FIVE ESTUARIES OFFSHORE WIND FARM

APPLICANT'S RESPONSE TO SECRETARY OF STATE REQUEST FOR INFORMATION (PART 2)

Application Reference: EN010115
Document Number: 10.74
Revision: A

Pursuant to: Decision Period Eco-Doc Number: 006220858-01 August 2025

Figure 15.1 VE ECC traffic survey data in relation to the OTE SPA and Red Throated Diver Count Data (Irwin et al. (2019))

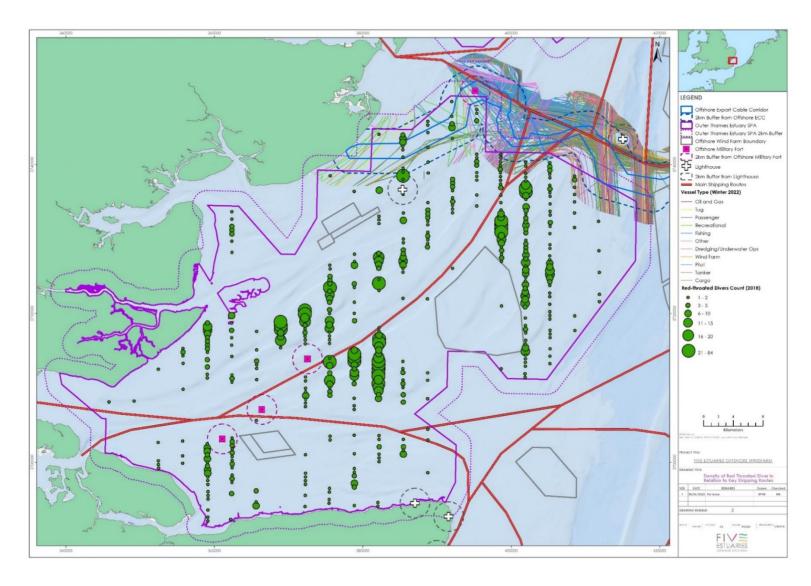
- 15.1.3 The two DWRs identified as areas of concern (Trinity and Sunk) are busy commercial shipping lanes. These routes experience high levels of vessel traffic year-round, which already results in displacement of RTDs from these habitats. As such, the ecological value of these areas for RTDs is already compromised (as illustrated in the figures below), and additional temporary construction activity will not result in significant further disturbance.
- 15.1.4 An additional figure has now been added below which highlights shipping traffic data collected during the baseline traffic surveys for VE. The two central routes which converge to create the red triangle on the map and cross the ECC, are the Sunk and Trinity DWRs. These data reiterate how busy this area already is.
